**PUD &
SUBDIVISION STAFF REPORT****Date: October 16, 2003****DEVELOPMENT NAME**

Joe Bullard Cadillac

Joe Bullard Cadillac Subdivision

LOCATION1407 and 1409 East I-65 Service Road South
(Southeast corner of East I-65 Service Road South
and Pleasant Valley [Road] Circle)**PRESENT ZONING**

SITE PLAN

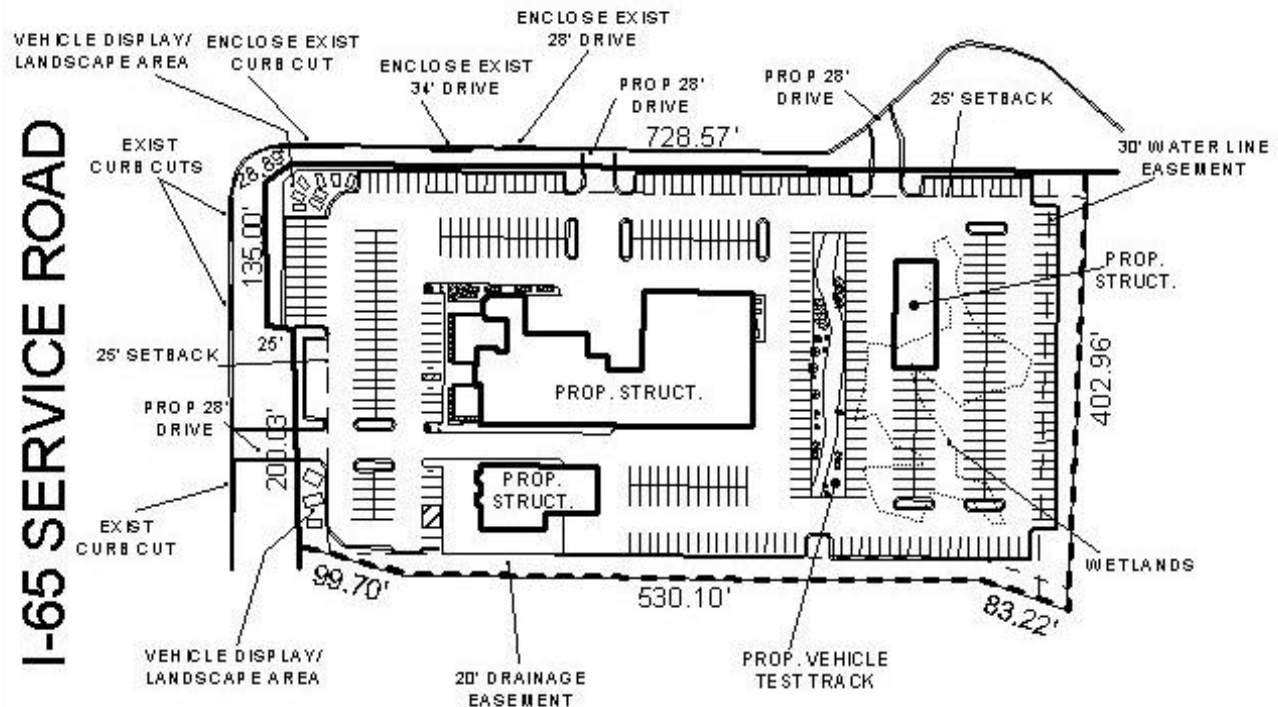
There are several existing curb cuts to both East I-65 Service Road South and Pleasant Valley Road Circle. The plan submitted specifically reflects the closure of the existing cuts to Pleasant Valley Road Circle and proposes two new cuts. The existing cuts to East I-65 Service Road South are shown on the plan with no reference to closure, and a new cut is also shown. The existing cuts serve no real purpose and should be closed; especially given their proximity to the intersection.

Another point is the plan reflects vehicles parked on landscaped areas. Parking for all vehicles should be paved, and all landscaped areas should be used exclusively for landscaping.

As a side note, the plan appears to reflect the provision of two free-standing signs. The site has over 1,000 feet of street frontage, and would therefore be allowed up to two free-standing signs.

RECOMMENDATION **Planned Unit Development:** based on the preceding, it is recommended that this application be approved subject to the following conditions: 1) that the development will be required to comply with Part I (Land Disturbance requirements) and Part II (Construction within a Flood Plain) of the COM's Storm Water Drainage Ordinance; 2) provision of a drainage easement along the stream running north-south (Hummer Test Track) that receives public storm water discharges from Pleasant Valley Road Circle and Pleasant Valley Road; 3) provision of a certified survey on Bolton's Branch prior to any permits being issued for this property (the survey to be performed by a licensed surveyor and coordinated with the Engineering Department prior to any clearing or other construction on the site), and a survey after all construction is complete to determine any impact on the flood handling capacity of the stream; 4) that the development will be held to the highest possible standards to prevent further degradation of the flood-handling capacity of the stream and the downstream properties; 5) developer to obtain all necessary federal, state and local approvals prior to the issuance of any permits; 6) the site is limited to the three proposed curb cuts, all existing cuts shall be closed, paving materials removed, and curbing and landscaping materials to be installed; 7) no parking of vehicles on landscaped or unpaved areas (Zoning Ordinance requires all parking areas to be paved); and 8) full compliance with all municipal codes and ordinances.

Subdivision: the plat meets the minimum requirements of the Subdivision Regulations and is recommended for Tentative Approval, subject to the following conditions: 1) that the development be required to comply with Part I (Land Disturbance requirements) and Part II (Construction within a Flood Plain) of the COM's Storm Water Drainage Ordinance; 2) provision of a drainage easement along the stream running north-south (Hummer Test Track) that receives public storm water discharges from Pleasant Valley Road Circle and Pleasant Valley Road; 3) provision of a certified survey on Bolton's Branch prior to any permits being issued for this property (the survey to be performed by a licensed surveyor and coordinated with the Engineering Department prior to any clearing or other construction on the site), and a survey after all construction is complete to determine any impact on the flood handling capacity of the stream; 4) the development will be held to the highest possible standards to prevent further degradation of the flood-handling capacity of the stream and the downstream properties; 5) developer to obtain all necessary federal, state and local approvals prior to the issuance of any permits; and 6) placement of a note on the final plat stating that the site is limited to the three proposed curb cuts, all existing cuts shall be closed, paving materials removed, and curbing and landscaping materials to be installed.
